Office Action Summary	Application No. 10/511,695	Applicant(s) HERCZEG, ATTILA	
	Examiner Krishnan S. Menon	Art Unit 1797

DETAILED ACTION

Claims 2,4,6,7 and 10-12 are pending as amended 12/5/08 in the RCE of 8/20/08; claim 12 is independent.

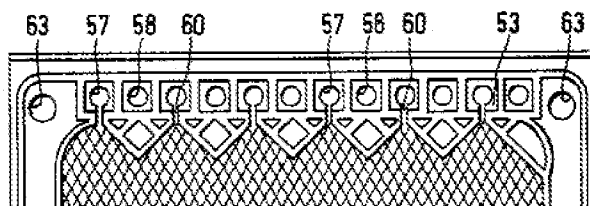
Please note that the US Patents to Grummert and Schmidt cited herein have PCT publications with earlier dates. These references teach the claimed invention – see the figures. They all have the feed, retentate and permeate passages sealed by resins that extend into the holes as well as to the periphery of the holes.

Pictures from applicant's disclosure, disclosed prior art, Grummert, Schmidt and Rogemont (in that order, from left to right) showing the permeate screen. All of them show the resin layer around the feed/retentate hole penetrating the screen material. They do not appear to form any non-uniformities in fluid flow therethrough. Particularly, compare the similarity of applicant's figure 13 to that of Rogemont. The resin layer is taught as penetrating across the screen layer in all the cited references.

The cited references all teach sealing material that extend uniformly into the permeate/filtrate passageways to form uniform flow channels, which is clear from the cited figures.
